# COMMUNITY BOARD FEEDBACK PACKAGE

**Business Name:** BOCCA DI BACCO

**Cafe Location:** 167 9 AVENUE, NEW YORK, NY, 10011

**Application Number:** 20240711010019

## SECTION 1: Site Plan

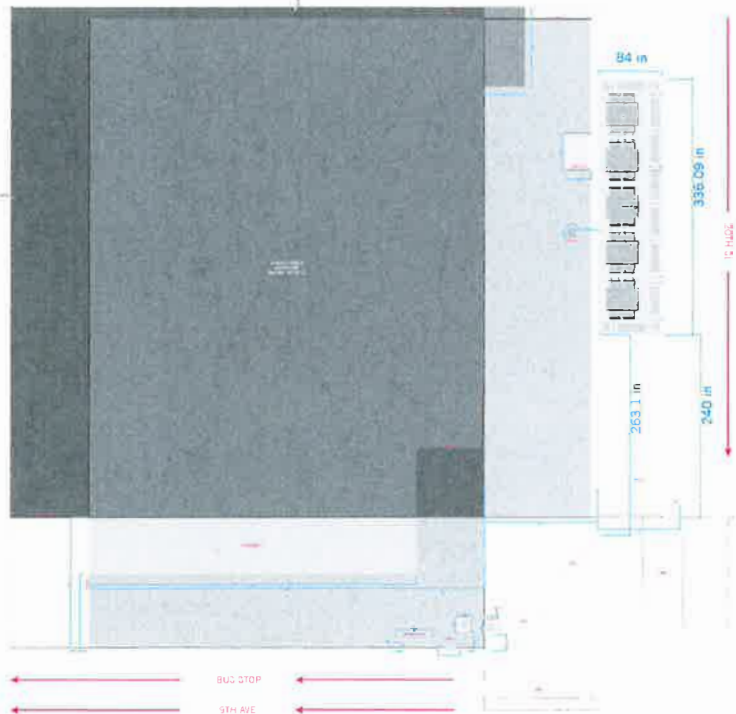
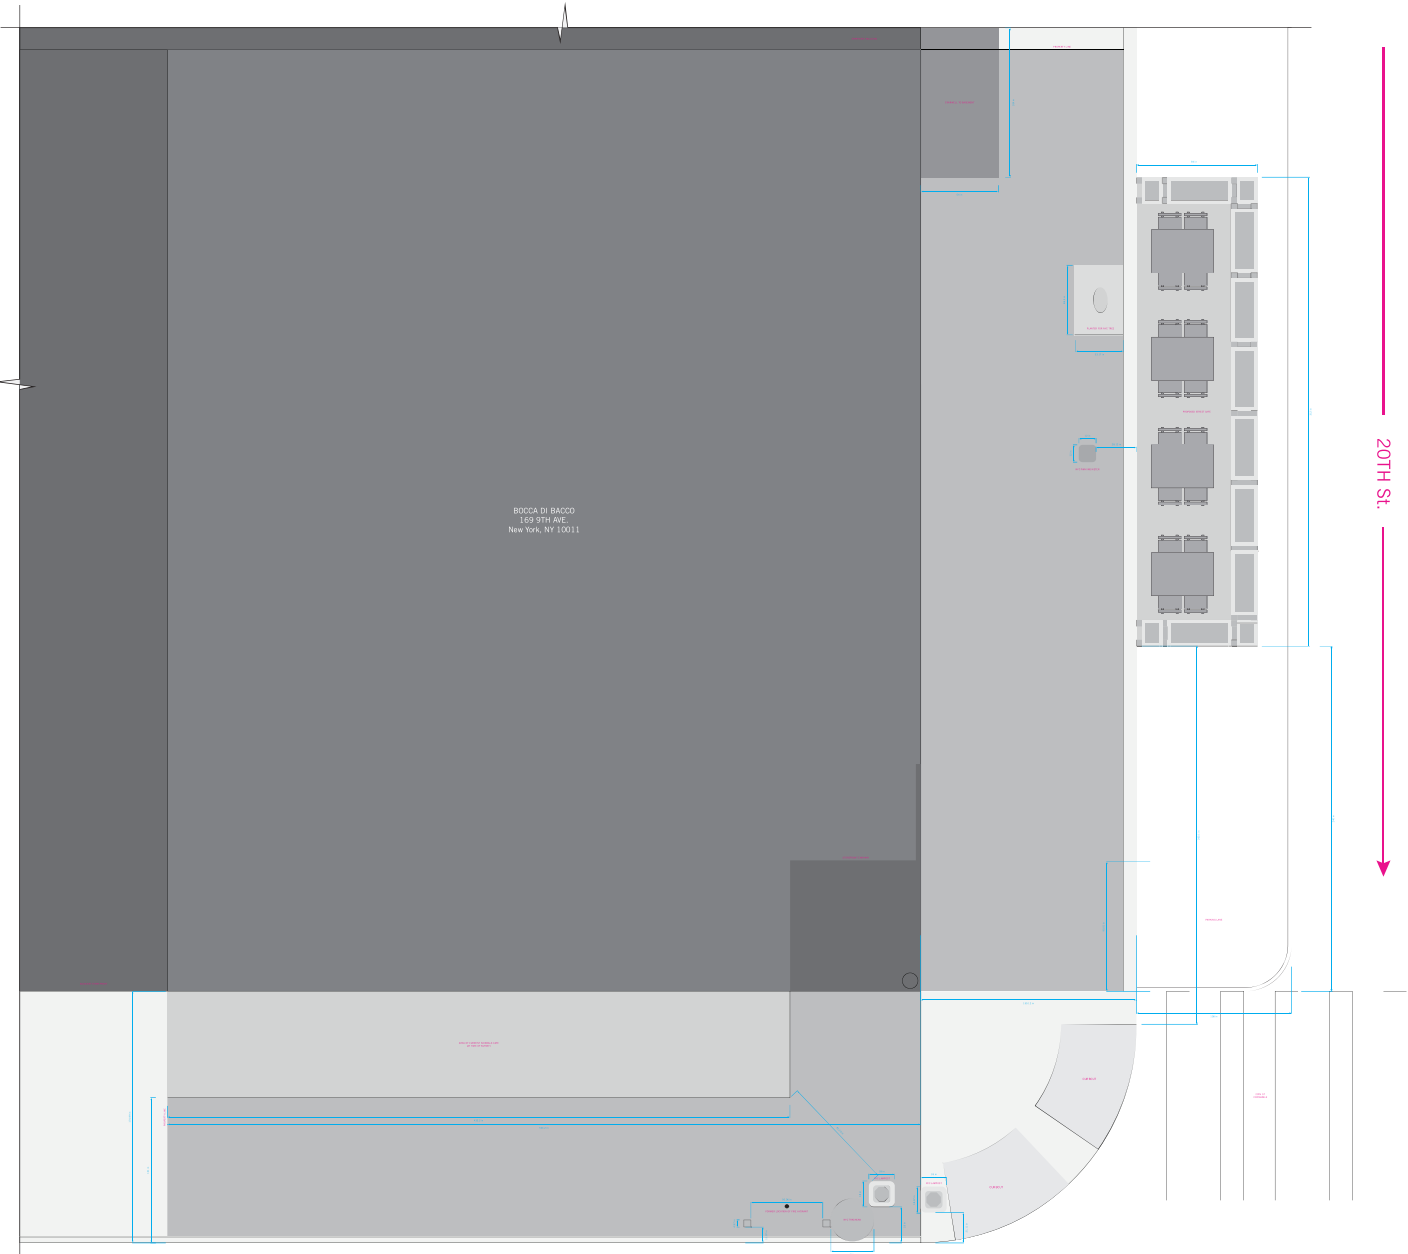
**Inaccurate Measurements:** The drawing properly represents that that cafe starts after the 20ft distance from the crosswalk and ends parallel to the basement entrance to the adjacent building. However the measurements are inaccurate: the length of the cafe is 26ft - not 28ft as indicated.

- 1. Reduce the length of the roadway cafe to 26 ft.**
- 2. Add serving aisles within the cafe**
- 3. Change to 4 tables and 16 chairs**
- 4. Remove the illegal sidewalk cafe on 9th Avenue**

\*REVISED  
SITE PLAN

Length of roadway cafe: 26 feet      Width of roadway cafe: 7 feet
